## PLANNING AND DEVELOPMENT SERVICES STAFF REPORT

For Planning Commission Meeting of March 6, 2007

**SUBJECT: Liberty Place Condominiums Rezoning and Planned Project Site Plan (northeast corner of Liberty and I-94) File Nos. 8254H15.2 and .5**

G. SHEET NO: S5

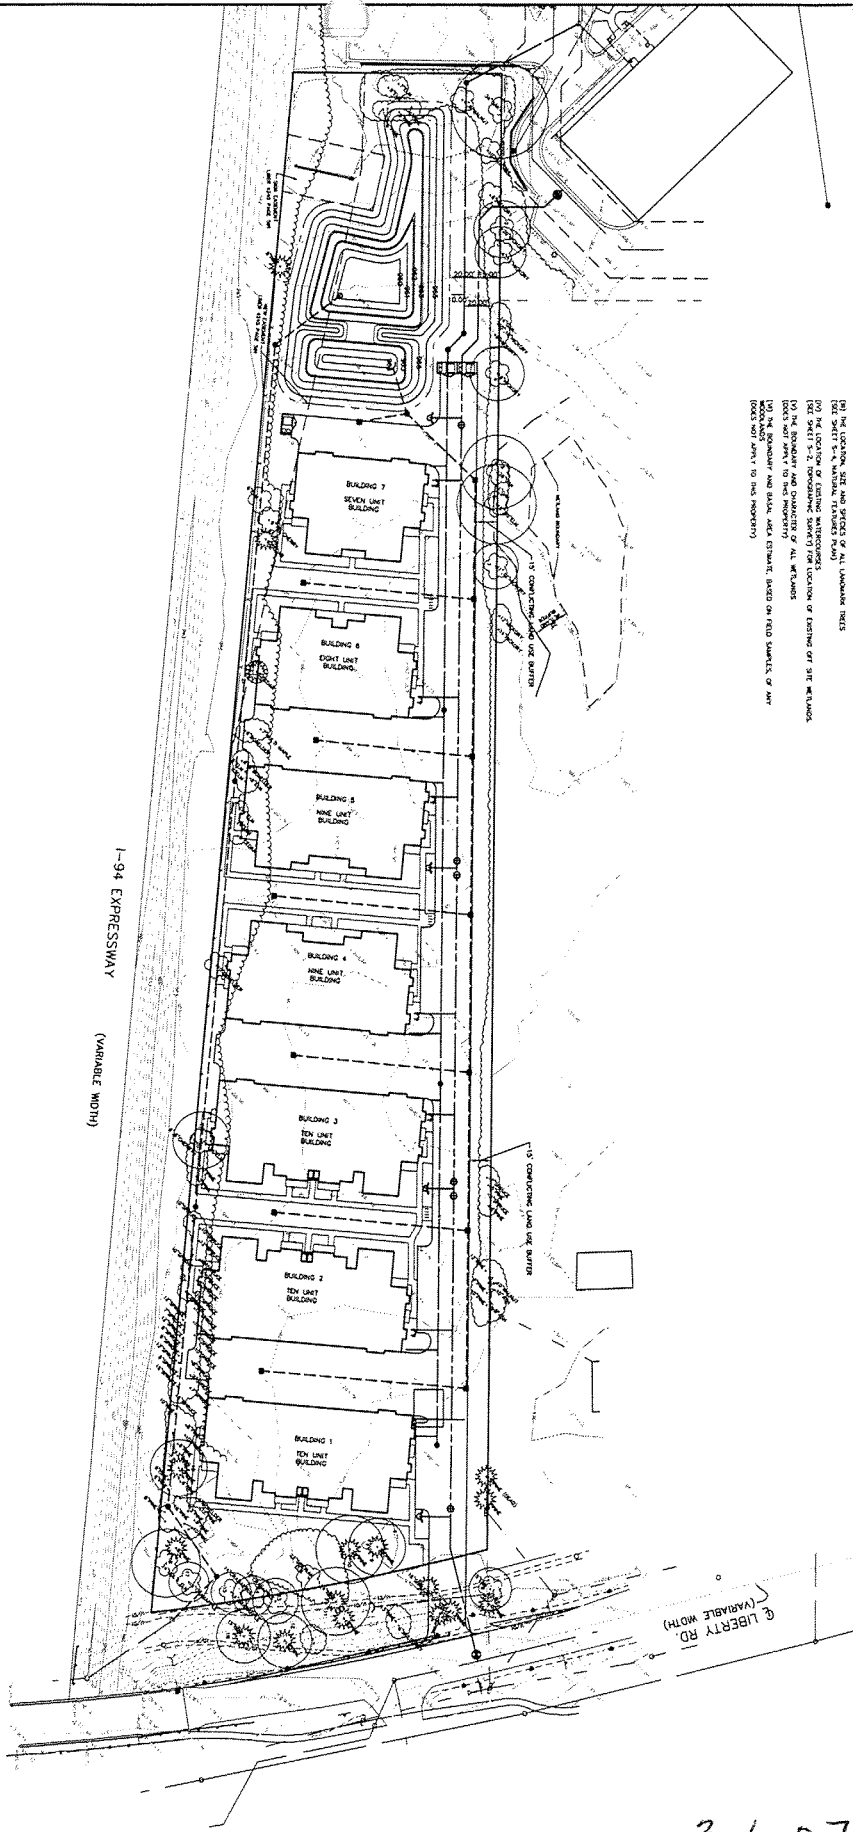
Site Layout – Building 1 has been shifted to the east to save 12 existing pine trees along I-94, including a 20-inch landmark pine tree. This reduces the number of landmark trees removed on site from three to two and reduces the number of non-landmark trees from 48 to 36. Approximately 138, six-foot tall Arbor Vitae trees are proposed to be planted along this west property line to screen the buildings from I-94. Due to the other buildings placement remaining unchanged, the planned project requested front setback of ten feet along I-94 remains. Two additional shade trees and a park bench are proposed for each of the three courtyards as shown on the attached landscape plan. These shade trees are part of the required mitigation trees.

Natural Features – The grading limits in the vicinity of landmark trees 2, 3, 4, 5, 6 and 7 located at the northeast corner of the site have been revised to maintain a minimum of ten feet of undisturbed area around these trees.

SHEET NO. S-10  
 SCALE: 1"=20'  
 DATE: 08/17/06  
 PROJECT NO.: 06-16013

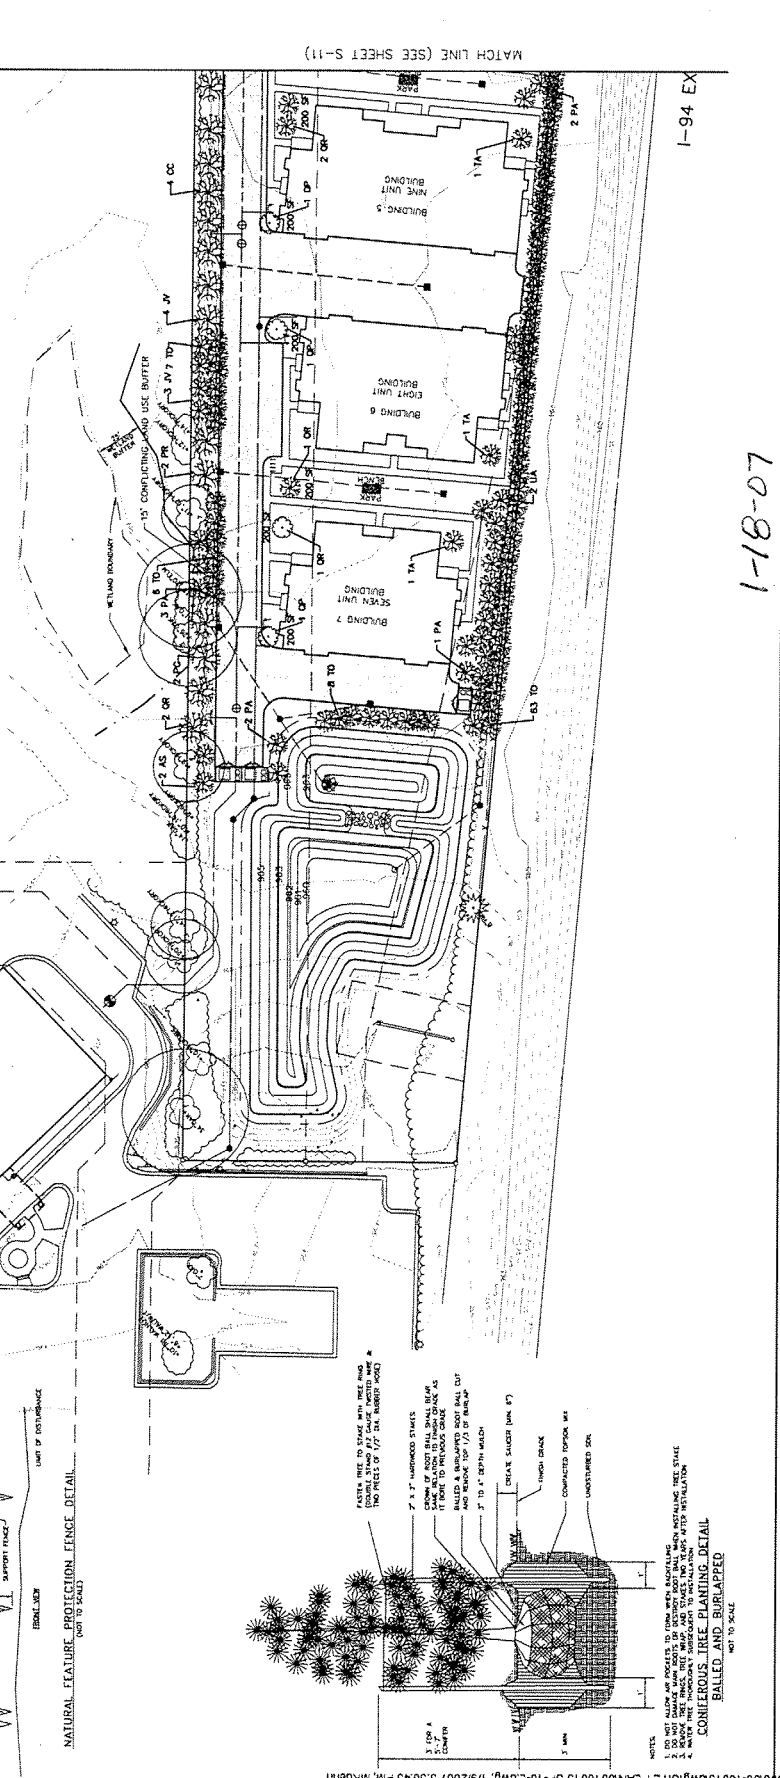
Land Development Coordinator - Grading limits are shown to pass within ten feet of landmark trees 2, 3, 4, 5, 6 and 7 for utility installations. The disturbance of these landmark trees is inconsistent with Chapter 57, Section 5:129, and the Guidelines for the Protection of Mitigation of Natural Features. Staff is not supportive of the proposed disturbance within the critical root zones of these trees for the current layout. If utilities are to remain in this location, staff requires boring rather than open trench if the ten feet of undisturbed area cannot be maintained around these trees.

Mitigation is required for landmark trees 2, 3, 4, 5, 6 and 7 under the currently proposed limits of earth disturbance. Please provide the requirement landmark tree mitigation if the proposed limits of disturbance is not moved beyond a minimum of ten feet from the base of the trees.
